CODE OF PRACTICE FOR LIGHTNING PROTECTION

AMENDMENT NO. 2

June 2004

Figure 3.8 – Earth electrode connection

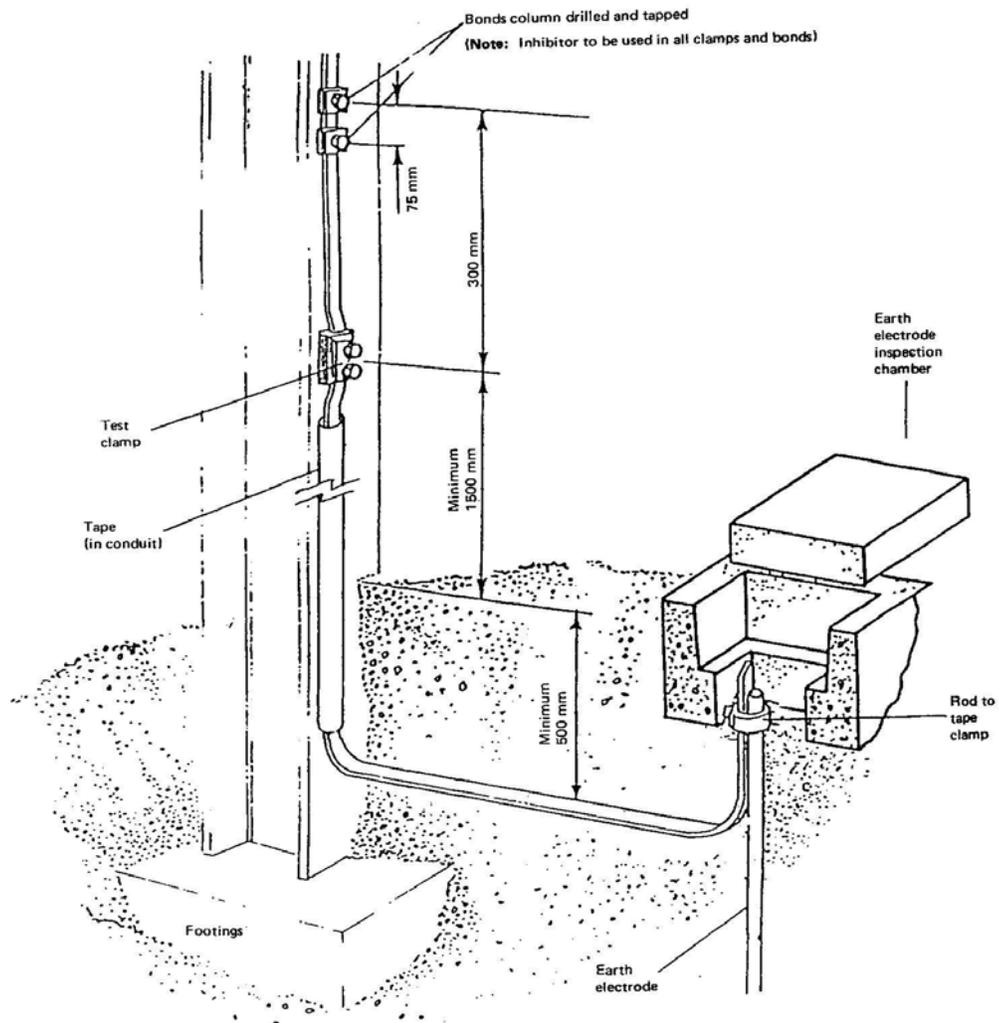
3. Page 47, Figure 3.8 Earth electrode connection

Replace the existing diagram with the attached Figure 3.8.
